Peach Bottom Atomic Power Station, Unit 3
Renewed Facility Operating License No. DPR-56
NRC Docket No. 50-278

Subject: Response to Request for Additional Information - License Amendment Request
Concerning Safety Limit Minimum Critical Power Ratio Change

Response to NRC RAIs for Peach Bottom Unit 3 Cycle 19 SLMCPR
Submittal

REQUEST FOR ADDITIONAL INFORMATION RELATED TO
LICENSE AMENDMENT REQUEST FOR TECHNICAL SPECIFICATION CHANGES
TO SAFETY LIMIT MINIMUM CRITICAL POWER RATIO VALUES
PEACH BOTTOM ATOMIC POWER STATION – UNIT 3
DOCKET NO. 50-278

Response to RAI-07

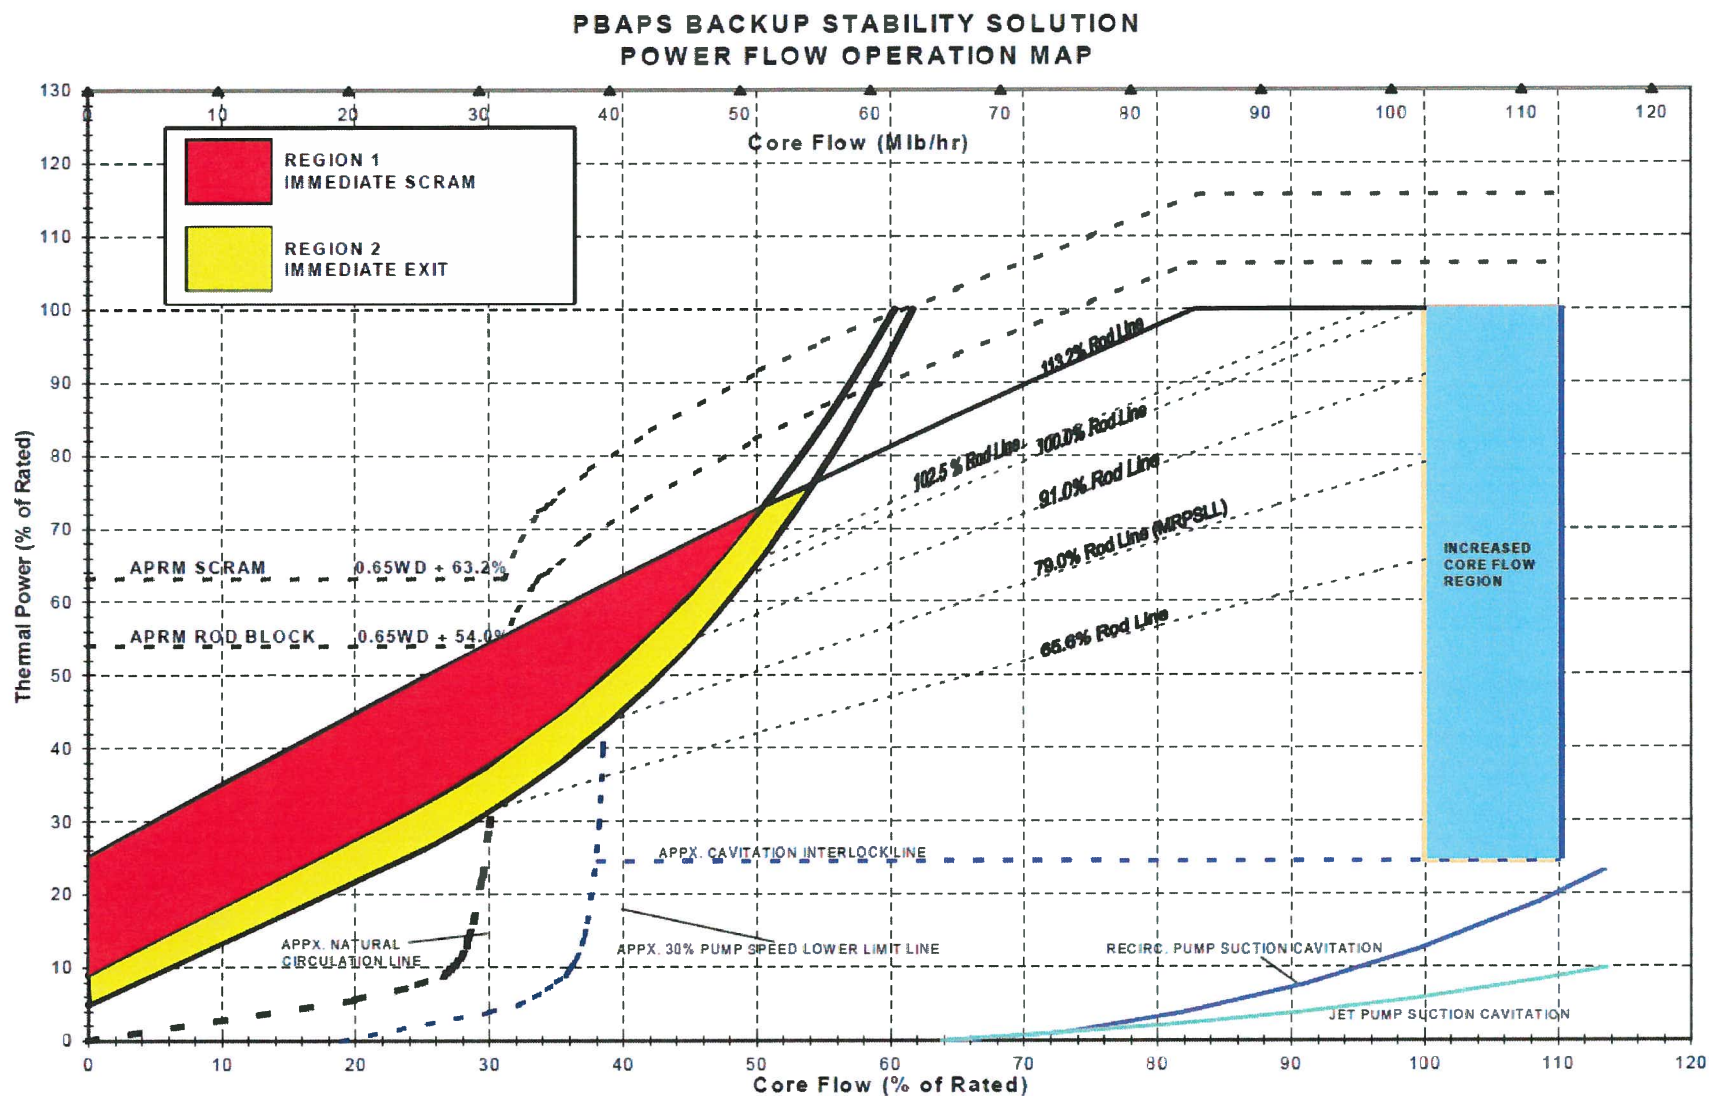
RAI-07: Provide an updated version of the power/flow map for PBAPS Unit 3, Cycle 19, operation including stability Option III features of scram region and controlled entry region for back-up stability protection.

The following is the power/flow map for back-up stability protection at Peach Bottom Atomic Power Station (PBAPS), Unit 3. PBAPS, Unit 3 does not use the controlled entry region. Instead, this region is conservatively treated as an immediate exit region (Region 2) on the power/flow map. Region 1 on the power/flow map is the scram region.
